Marksman & Ranger 2 Release Notes

Release Notes 6.04.04

MMR2-32967 Remove excluded data from the after plots

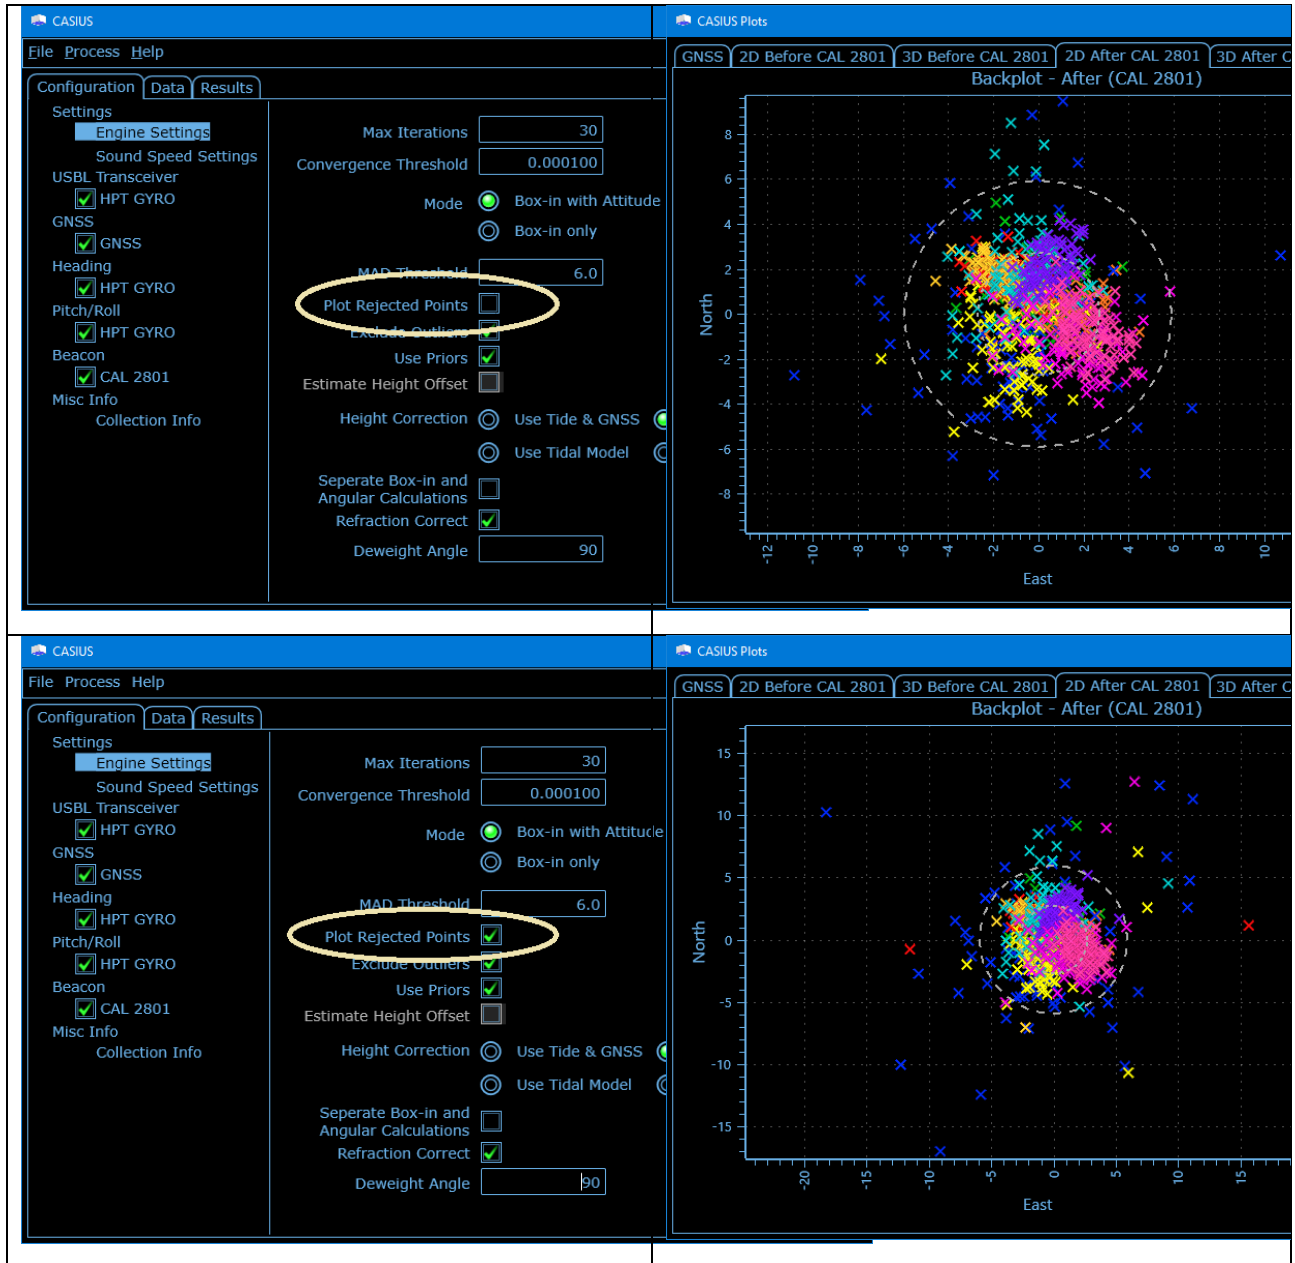
Previously all observations (including those that had been excluded) were shown on the CASIUS calibration result plots. By default, this data is now not plotted so that the charts auto-zoom to show the result more clearly. If the user wishes to see the excluded observations, then select the 'Plot Rejected Points' option in the 'Engine Settings', and re-process the CASIUS to generate new plots:
